Remarks

Claims 1, 3 and 5 have been amended. Claims 2, 4, 6 and 7 have been cancelled. Claims 1, 3, and 5 are pending.

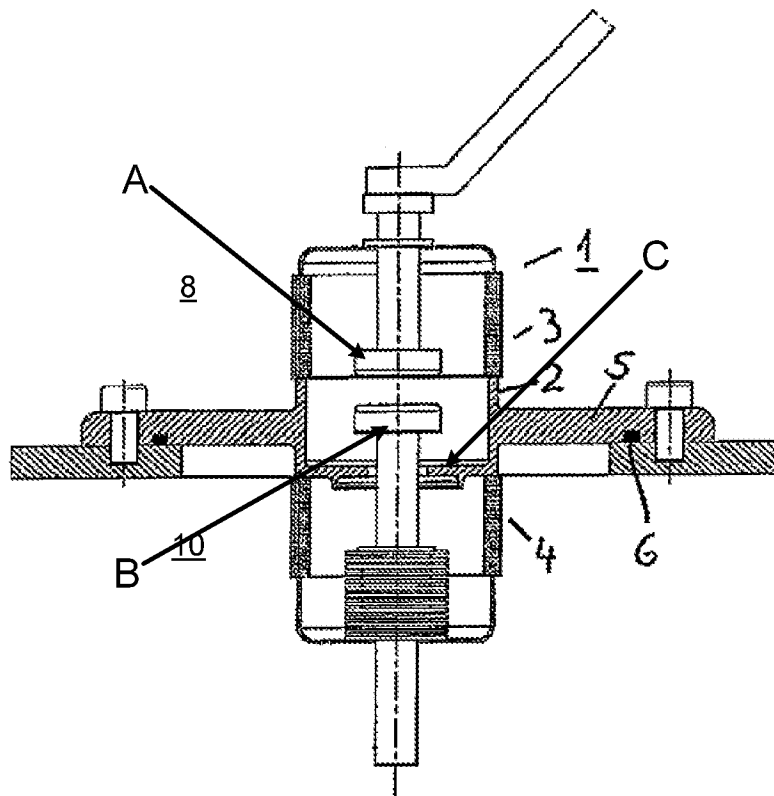
Three position vacuum chamber switches are well known in the art. Three position switches include a connected position, a disconnected position, and a grounding position. Par. 3. With reference to the figure below, it is well known in the art that such switches include a stationary contact (A) and a moving contact (B). The moving contact is driven up or down by a drive. Par. 3. In this manner, the moving contact (B) may be brought into contact with the stationary contact (A), may be brought into contact in the opposite direction with the metallic center part (C) which is grounded, or may be positioned in between, as shown below.

One of ordinary skill in the art would readily understand the above drawing and the operation of the three position vacuum switch without undue experimentation. Accordingly, it is believed that the Examiner's rejections under 35 U.S.C. 112, paragraph one, are believed to be improper.
